Bulletin No.: PIT5930A  
Published date: 02/7/2023

### PIT5930A Hood Paint Damage At The Edges Of The Hood Center Molding

Brand:	Model:	Model Years:	VIN:		Engine:	Transmissions:
			from	to		
Chevrolet	Silverado 1500 New(RPO J22, VIN Digit 5 = A or D)	2022	All	All	All	All
Chevrolet	Silverado 1500	2023	All	All	All	All

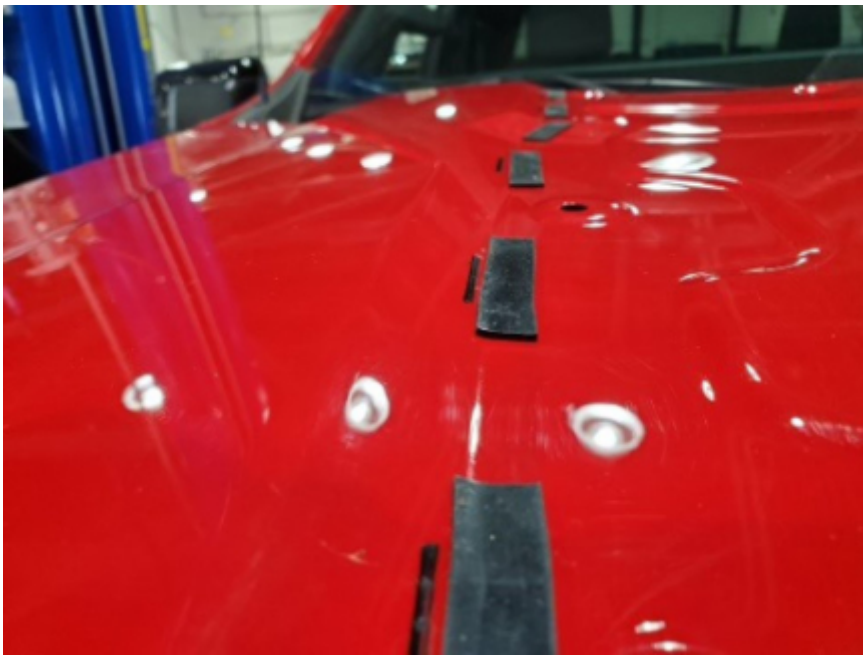
5. Cut the tape into several 20 mm and 30-40 mm long pieces. You will be using a combination of each length of tape to place on the hood around the perimeter where the hood center molding mounts, as shown below in the following steps.
